SUBJECT: VOIDED APPLICATION

License No. 28-07946-06  
Docket No. 030-21063  
Control No. 122729

This is in reference to the letter dated December 21, 1995 from Robert S. Sletten requesting to amend License No. 28-07946-06. In order to continue our review, we need the following additional information:

The US Army Cold Regions Research and Engineering Laboratory (CRREL) currently holds a license from the Nuclear Regulatory Commission (NRC) Number 030-21063 for sealed sources. We are requesting issuance of an amendment to this license to add the use and possession of byproduct material in other than sealed form as defined in 10 CFR part 30. We request possession and use of the following isotopes for laboratory research at the CRREL facility:

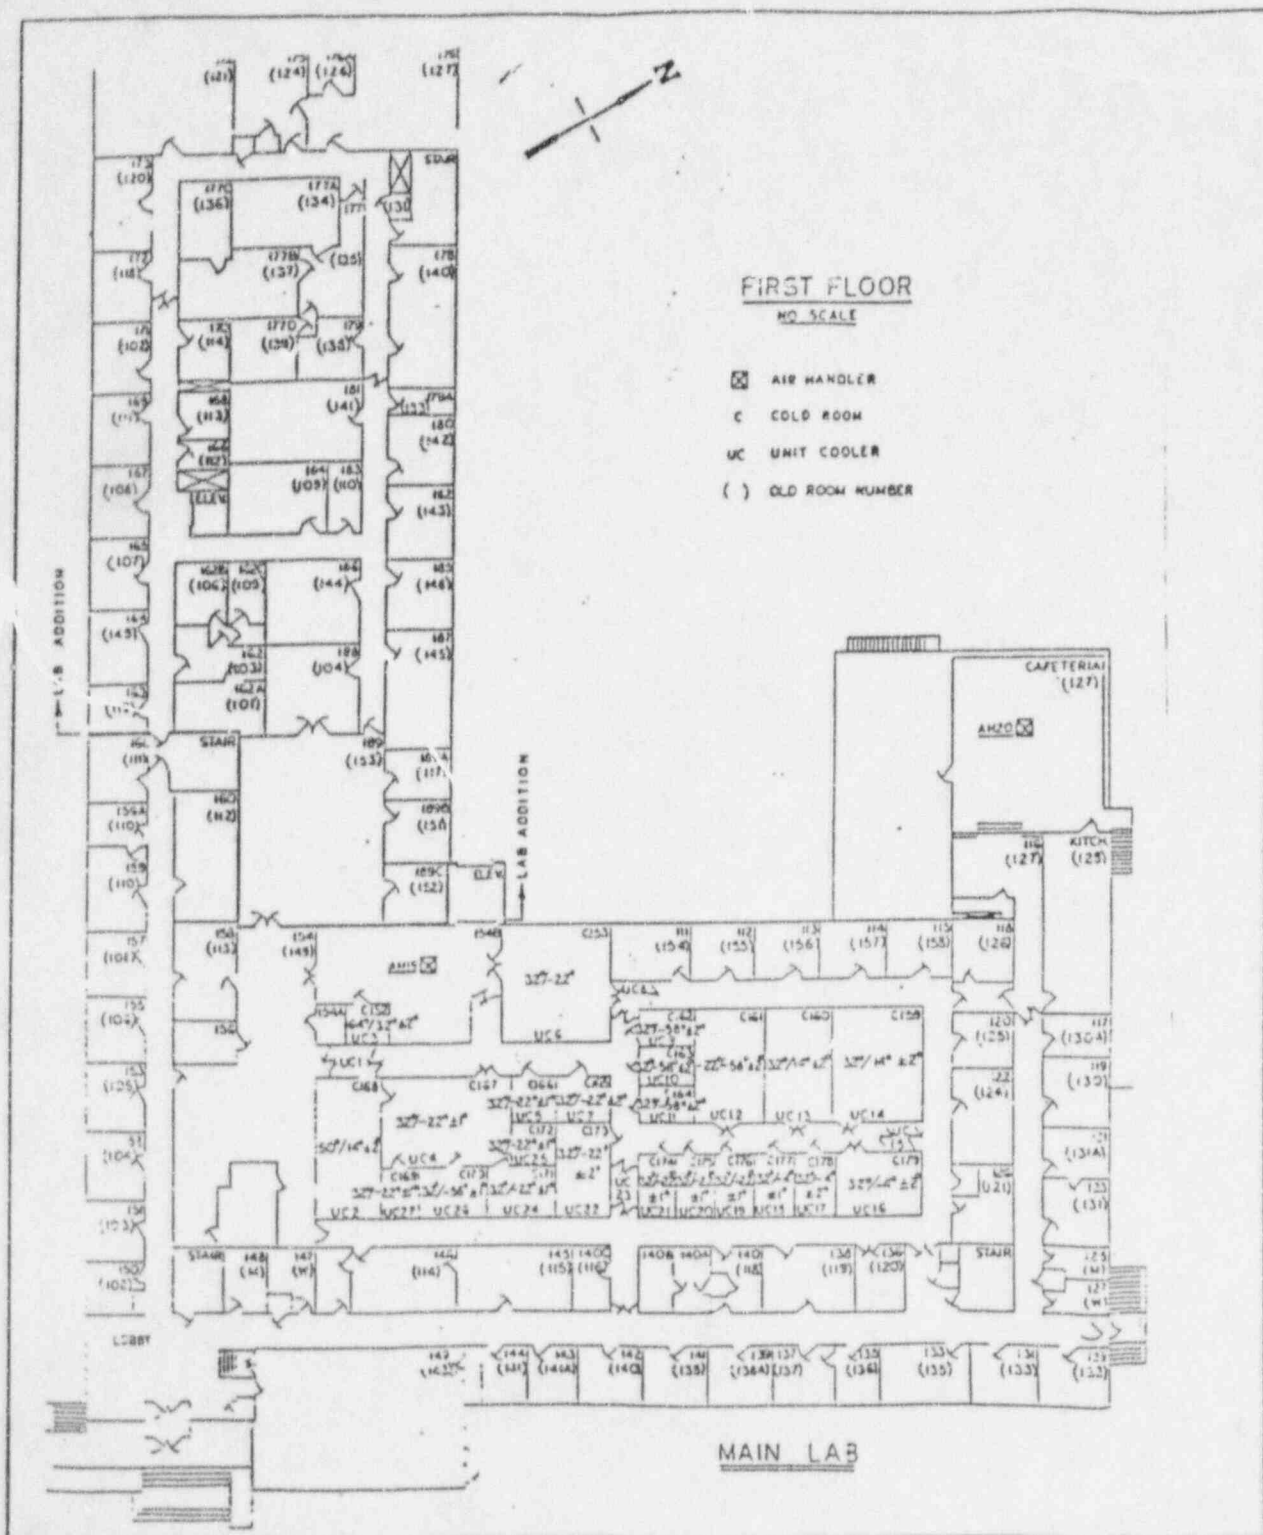
31. Pages 17 and 18 of the Radiological Safety Program provide brief descriptions of the rooms where radioactive material will be used. Please describe the facilities and equipment (e.g., remote handling equipment, storage containers, shielding, fume hoods) to be made available at each location where licensed material will be used. Submit a description of the areas assigned for the receipt, storage, preparation, and measurement of licensed materials. Submit a diagram showing the locations of shielding, the proximity of radiation sources to unrestricted areas, and other items related to radiation safety. For facilities where licensed materials may become airborne, include schematic descriptions of the ventilation system, with pertinent airflow rates, pressures, filtration equipment, and monitoring instruments. Diagrams should be drawn to a specified scale, or dimensions should be indicated.
